Access Compliance Report

Public Rights-of-Way

Intersection ID: N/A	Main Street: STEEL_CREEK_RD	Cross Street: SHOPTON_RD	Location: S
ADA ID: 4787FA75D865	Ramp Type: Perp	Initial Pass/Fail: Fail	Overall Compliance: No
Codes/Mitigation Info/Possible Solution		Field Measurements/Component Compliance	
Severity Score: 10

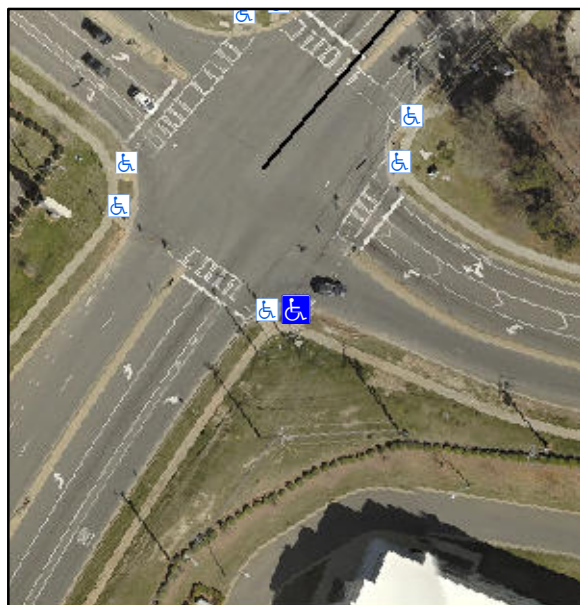
Not Found, R304.5.1, R304.5.3

Compliance	Description	Data	Compliance	Description	Data
N/A	Ramp Length (in)	94.0	Yes	Ramp Slope (%)	5.5
No	Ramp Width (in)	47.0	No	Ramp XSlope (%)	4.6
N/A	Flare Type LT	N/A	N/A	Flare Type RT	N/A
N/A	Flare Slope LT (%)	N/A	N/A	Flare Slope RT (%)	N/A
N/A	Flare Traversable LT?	N/A	N/A	Flare Traversable RT?	N/A
N/A	Landing Length (in)	N/A	N/A	DWS Provided?	N/A
N/A	Landing Width (in)	N/A	N/A	DWS Contrast?	N/A
N/A	Landing Slope (%)	N/A	N/A	DWS Length (in)	N/A
N/A	Landing X Slope (%)	N/A	N/A	DWS Full Width?	N/A
N/A	Landing Curb? (Y/N)	N/A	N/A	DWS Offset (in)	N/A
N/A	Shared Landing?	N/A			
N/A	Gutter Ponding?	N/A	N/A	Gutter Slope (%)	N/A
N/A	Gutter Lip Ht (in)	N/A	N/A	Gutter X Slope (%)	N/A
N/A	Painted X Walk1?	Yes	N/A	Painted X Walk2?	N/A
	X Walk 1 Direction	To NE		X Walk 2 Direction	N/A
N/A	X Walk 1 Width (in)	109.0	N/A	X Walk 2 Width (in)	N/A
	X Walk 1 Slope (%)	1.9		X Walk 2 Slope (%)	N/A
	X Walk 1 X Slope (%)	1.2		X Walk 2 X Slope (%)	N/A

Remove & Replace Entire Ramp.
